ZONING BOARD OF APPEALS APPLICATION
TOWN OF SIMSBURY, 933 HOPMEADOW STREET, SIMSBURY, CT 06070

Location of Property: 10 Cedar Glen Road, West Simsbury, CT 06092
(number and street name)

PROPOSED ADDITION
10 CEDAR GLEN
PROPERTY OF
CURTIS LOONEY & MANU SINGH-LOONEY
SIMSBURY, CONNECTICUT

Letter from Architect

REAR ELEVATION
SCALE: 1/4"=1'-0"

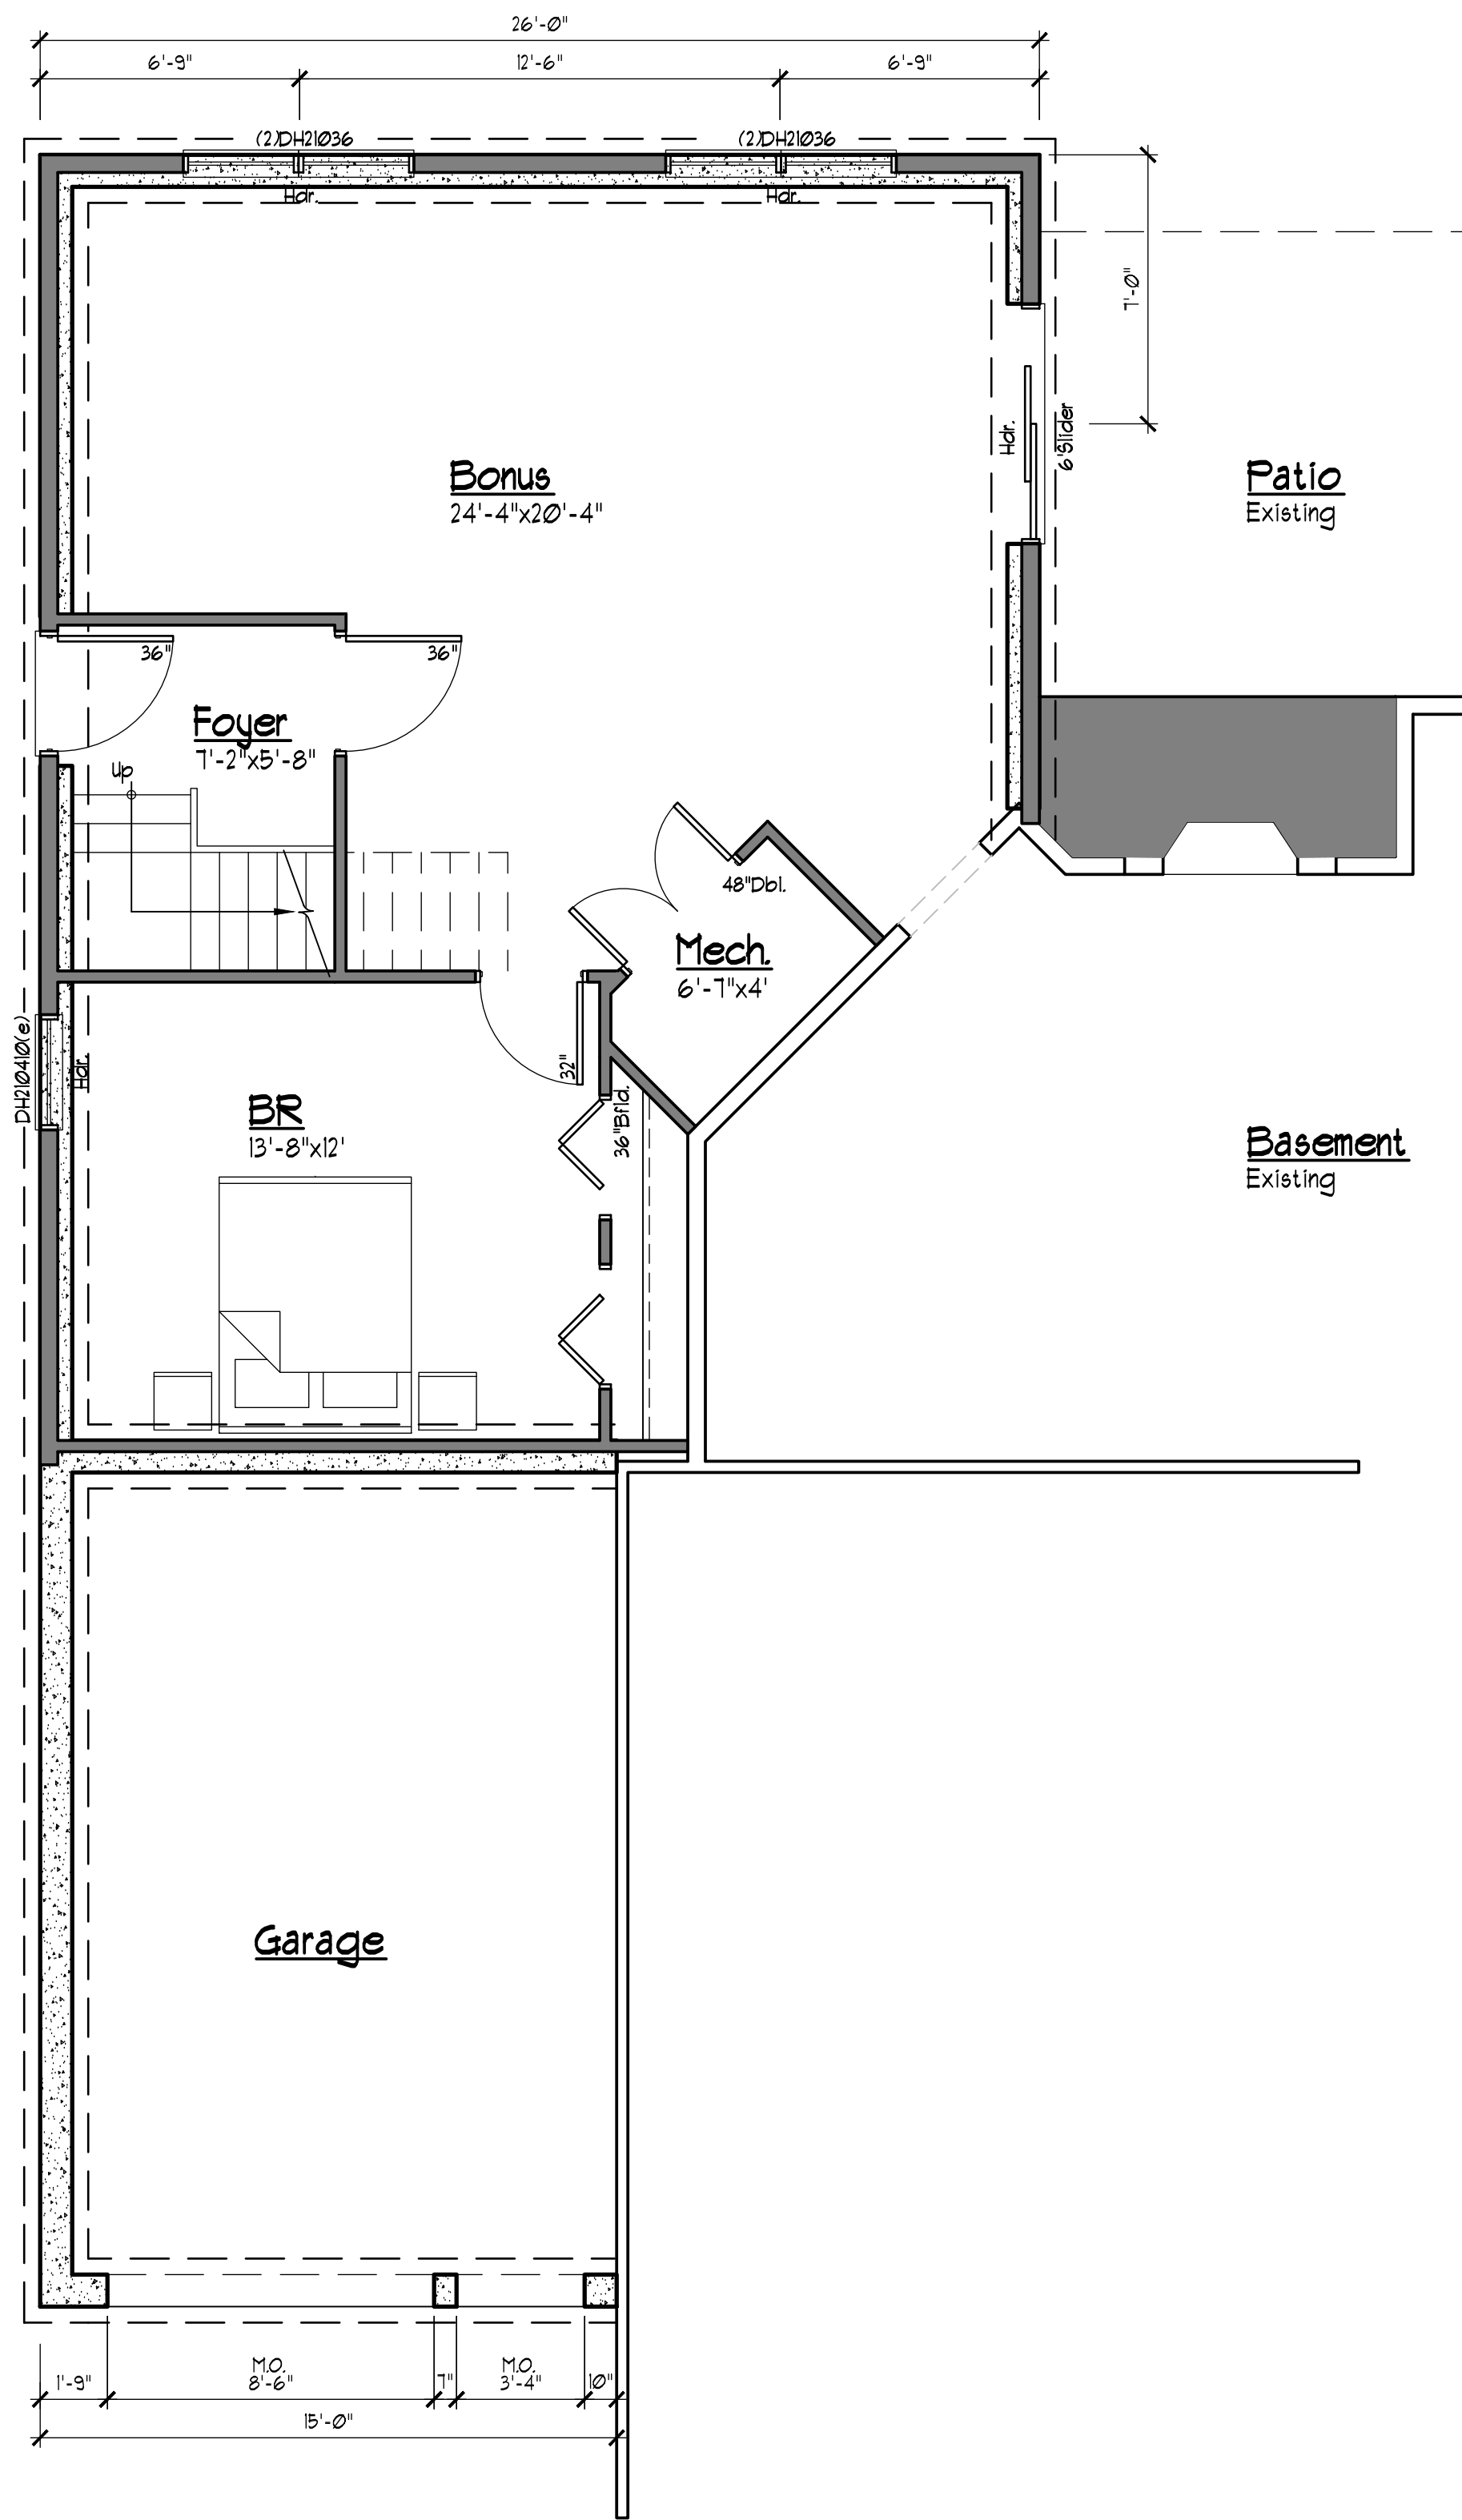
Revised Submission
Changes:
Door removed to the right of the garage.
Addition depth reduced.

FIRST FLOOR PLAN
SCALE: 1/4"=1'-0"
889 Heated Sqft. - FIRST FLOOR

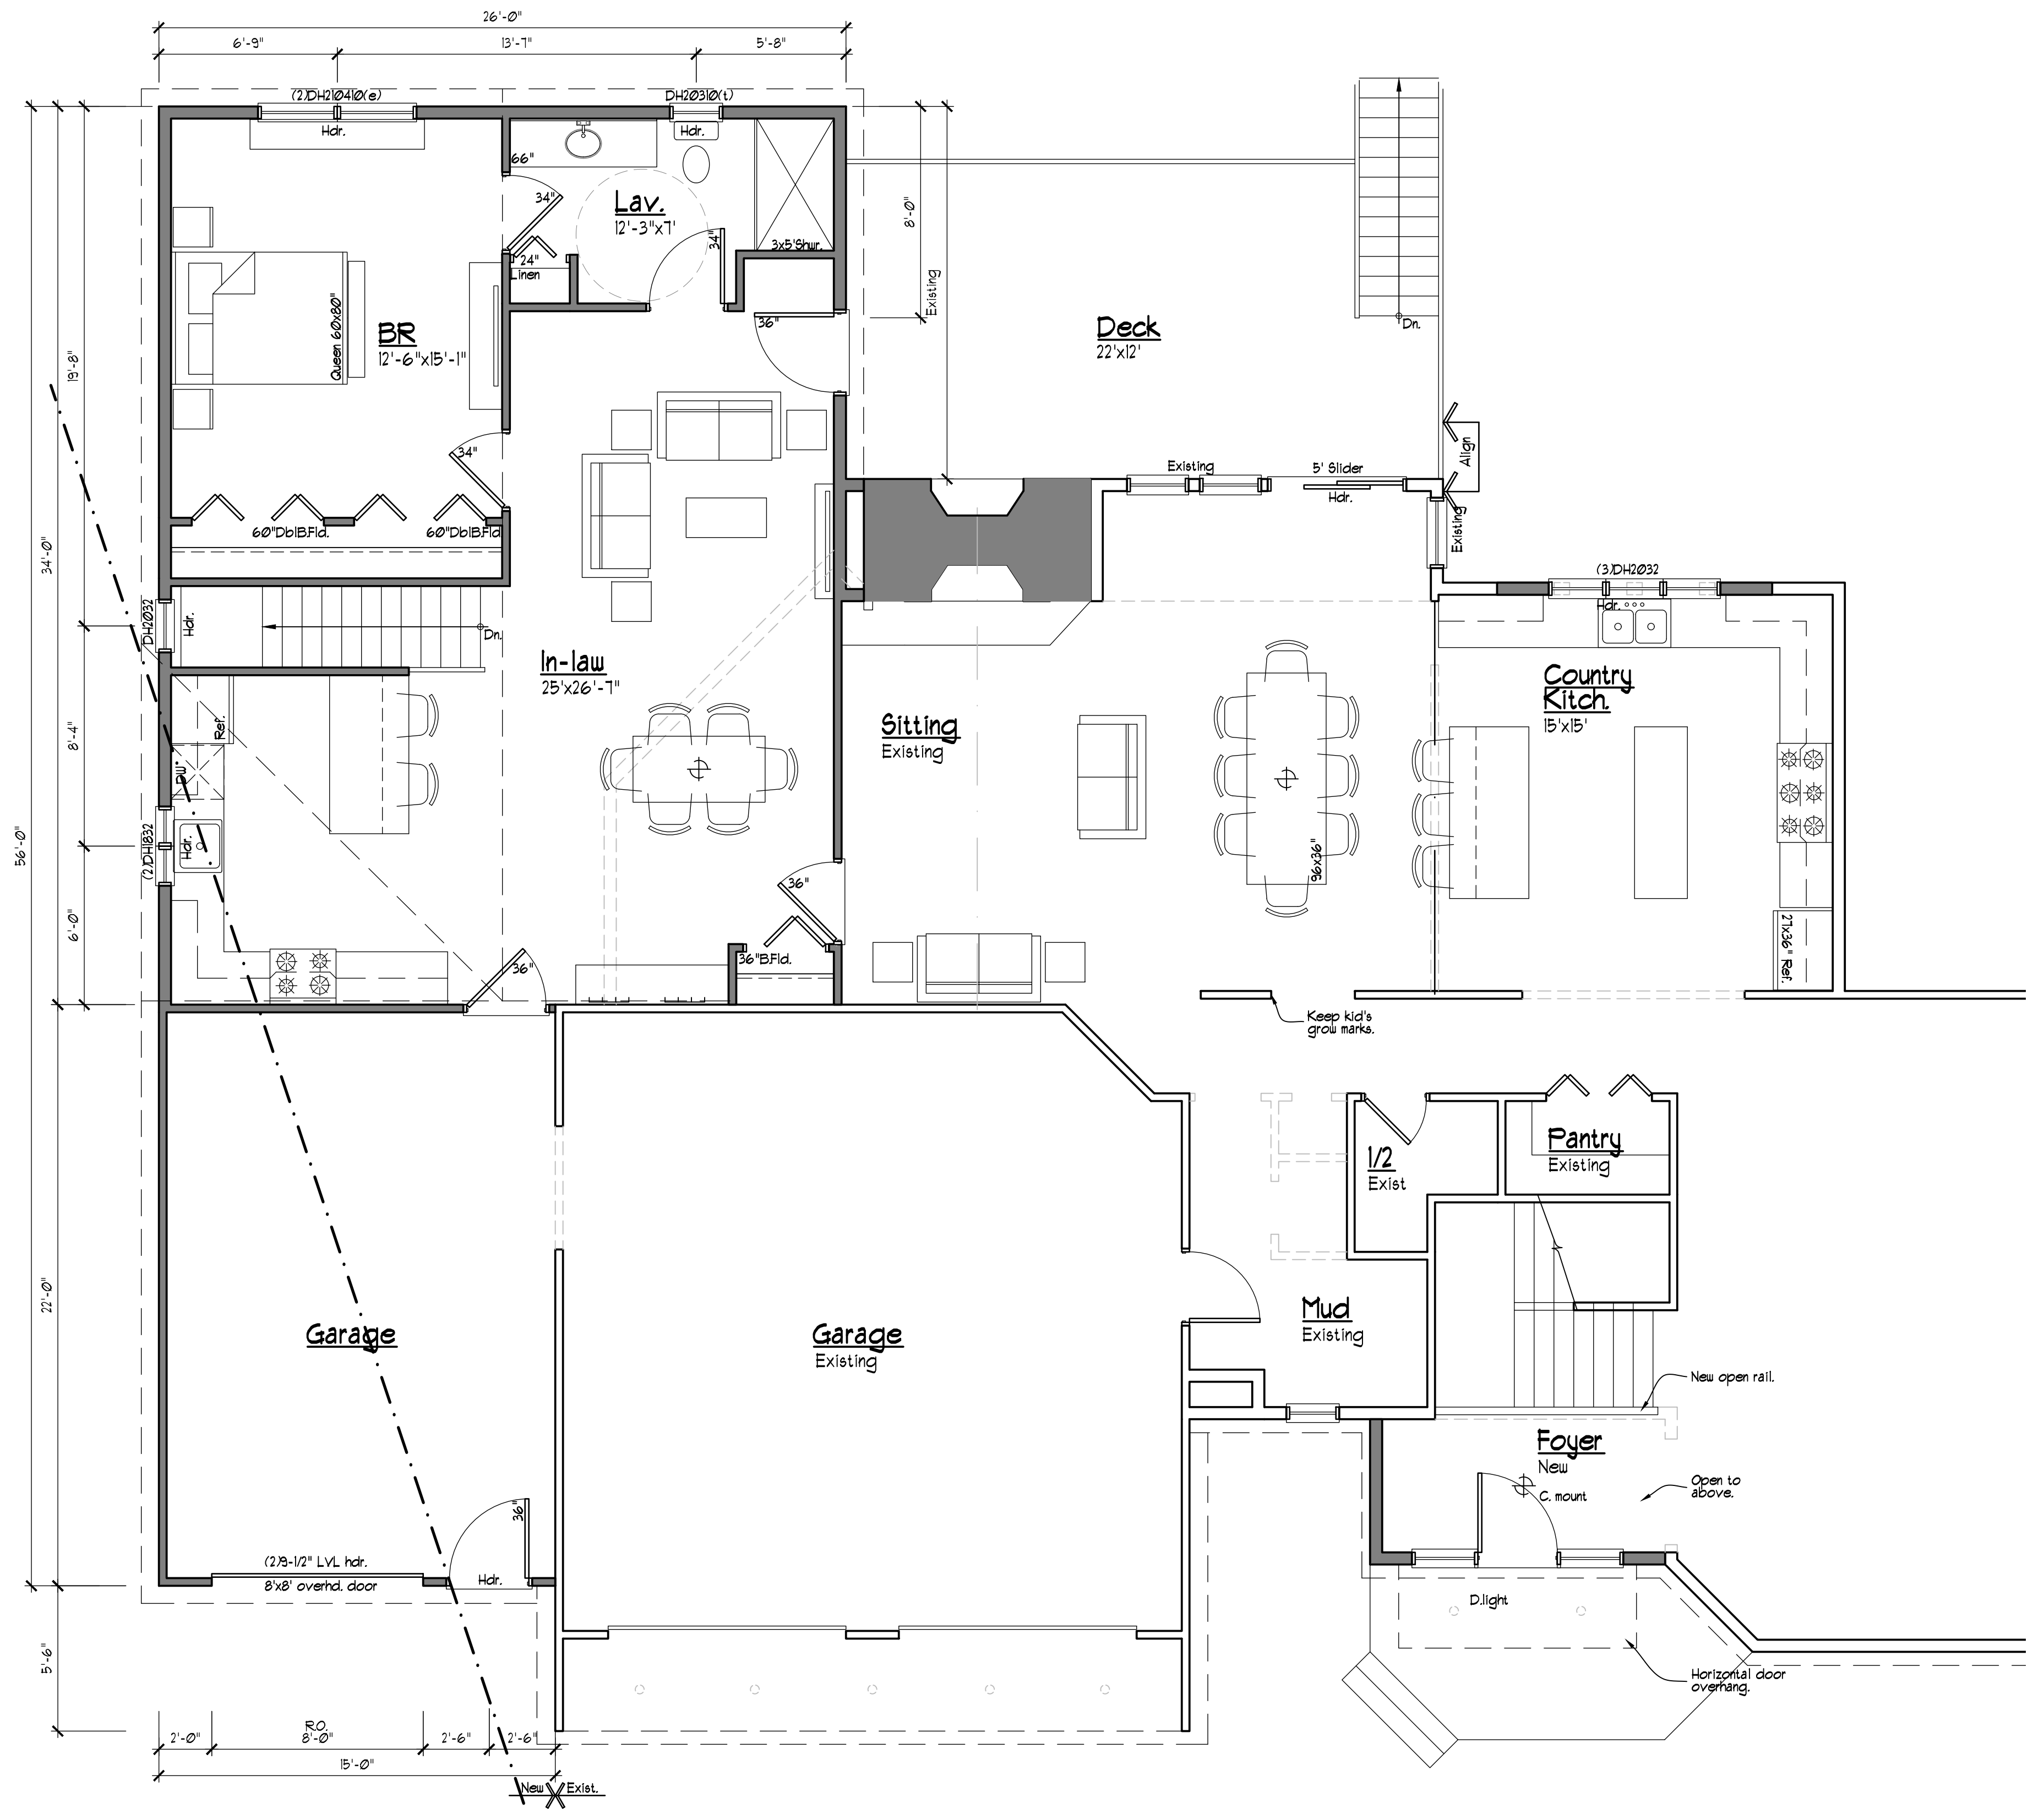
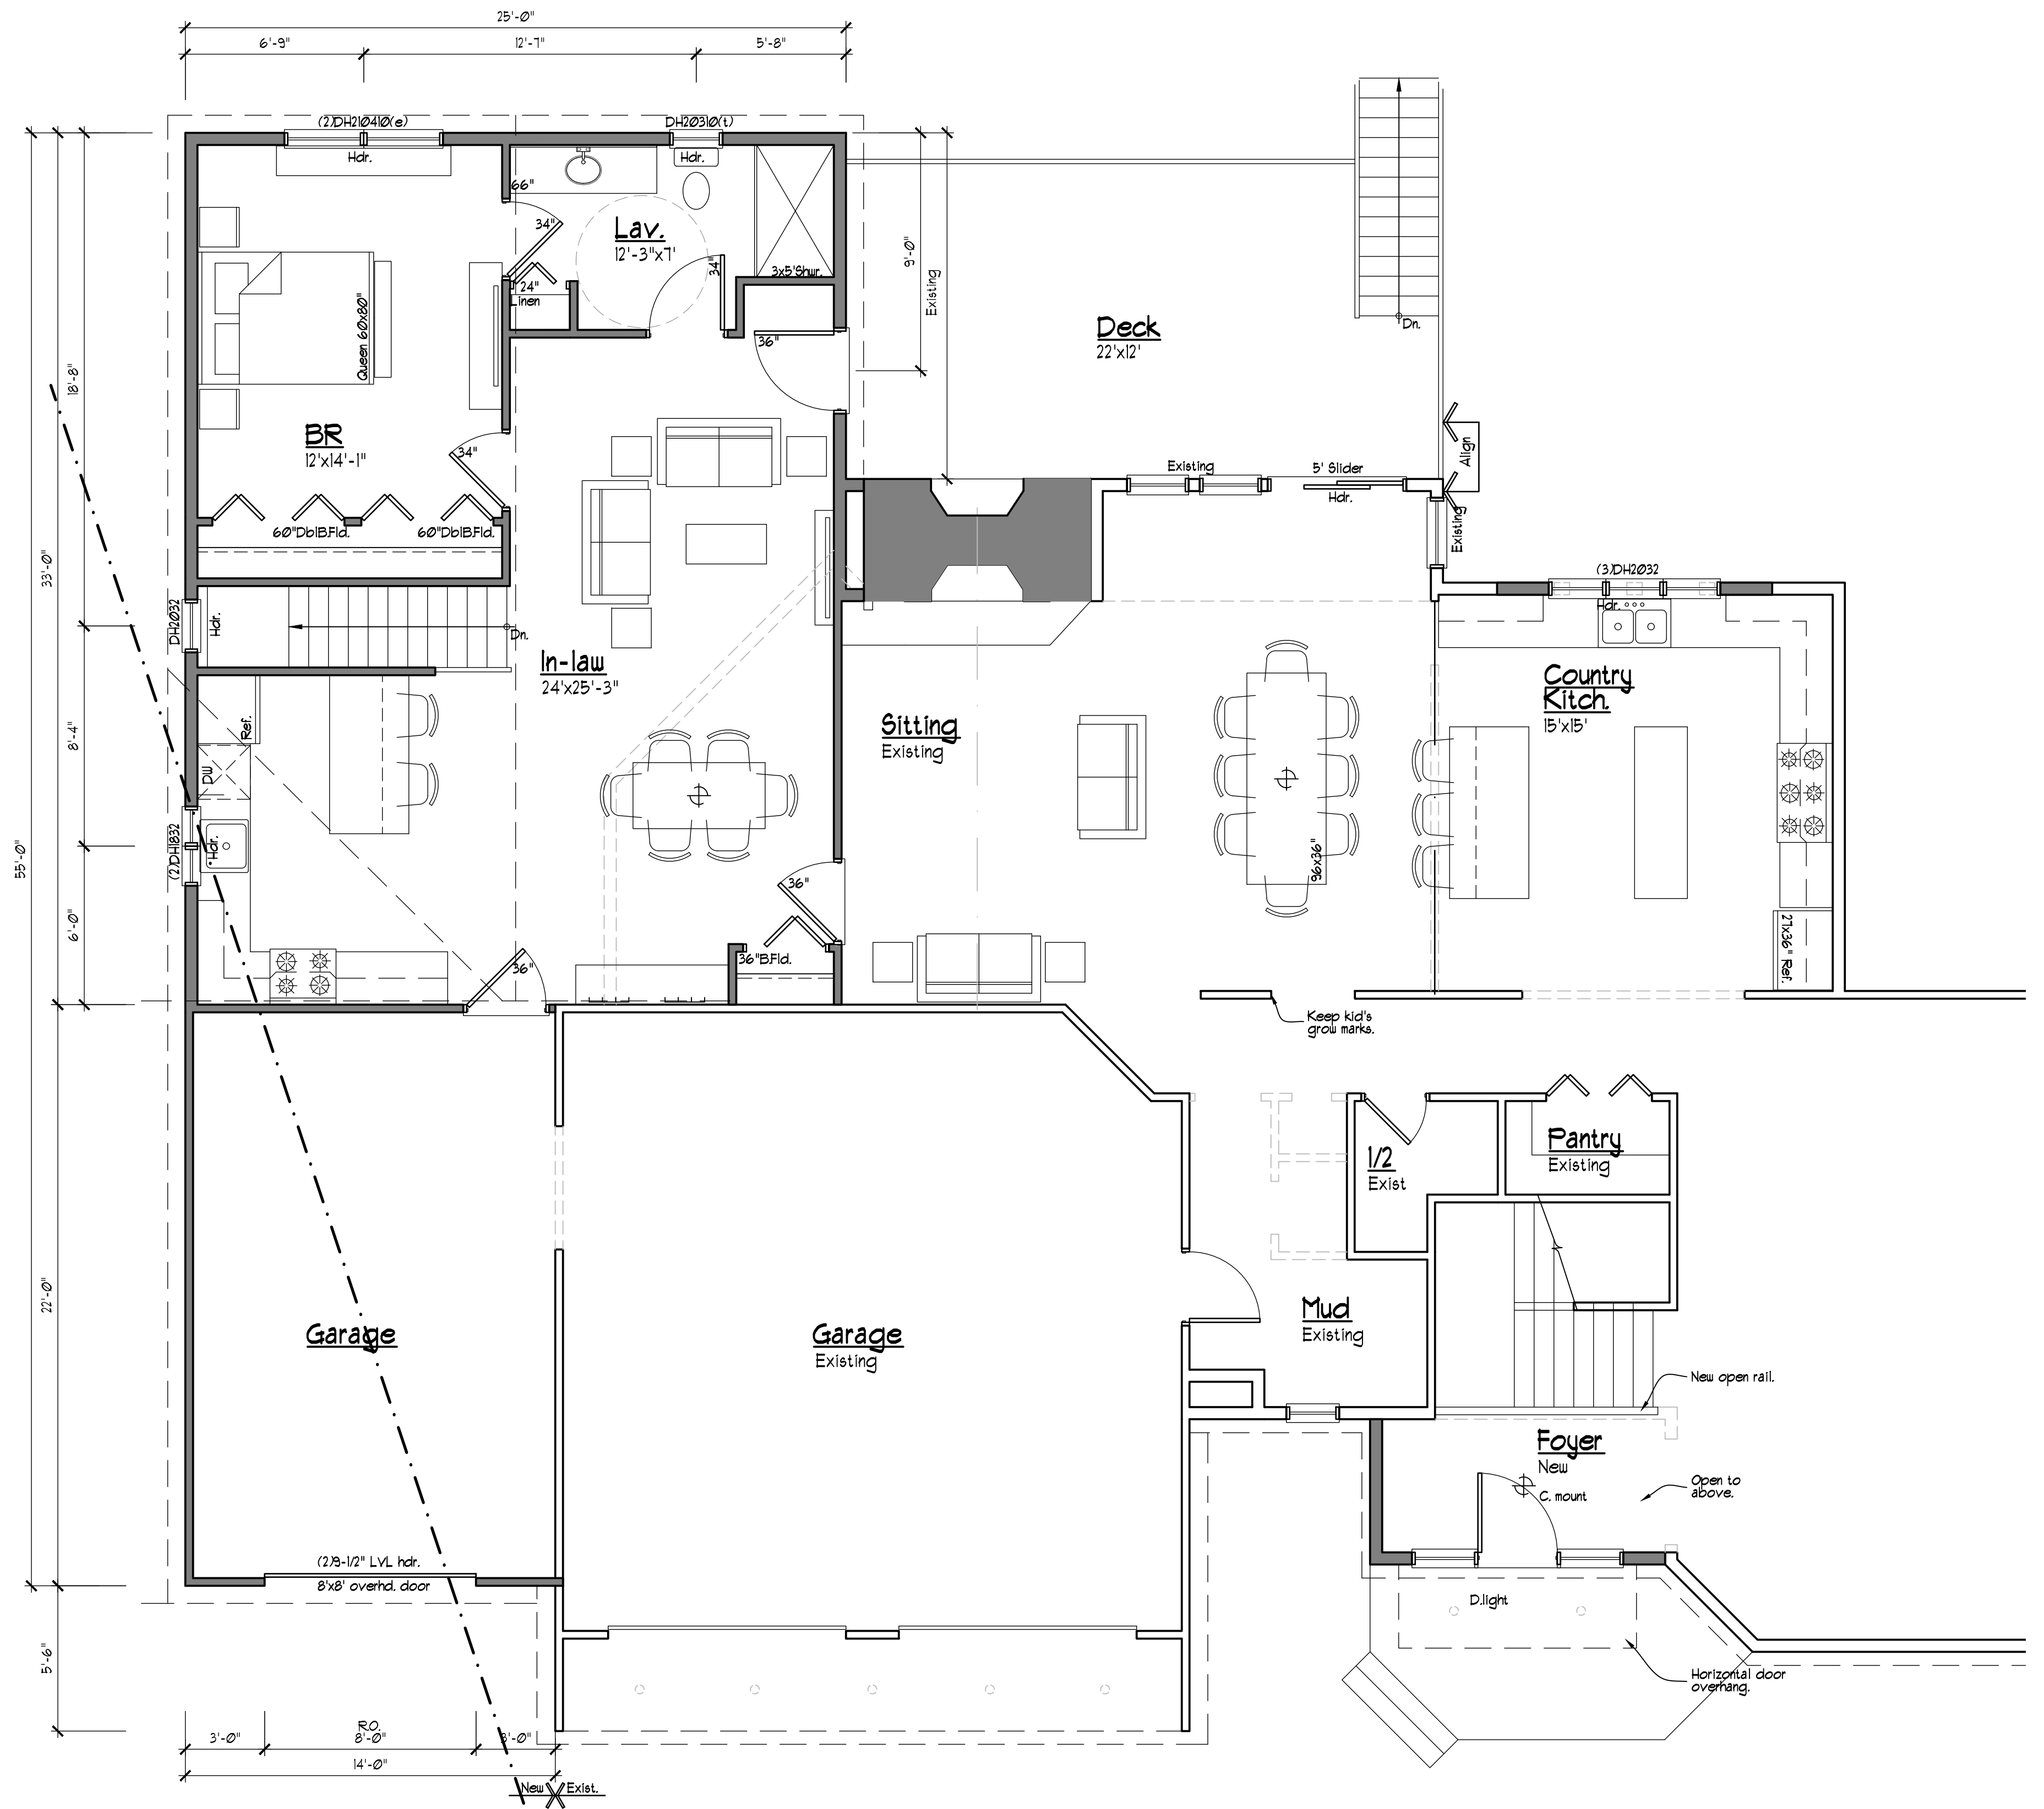
Changes:
 ADU Size: 650SF to 606SF
 44SF Reduction

Addition Size: 1,713SF to 1,636SF
 77SF Reduction
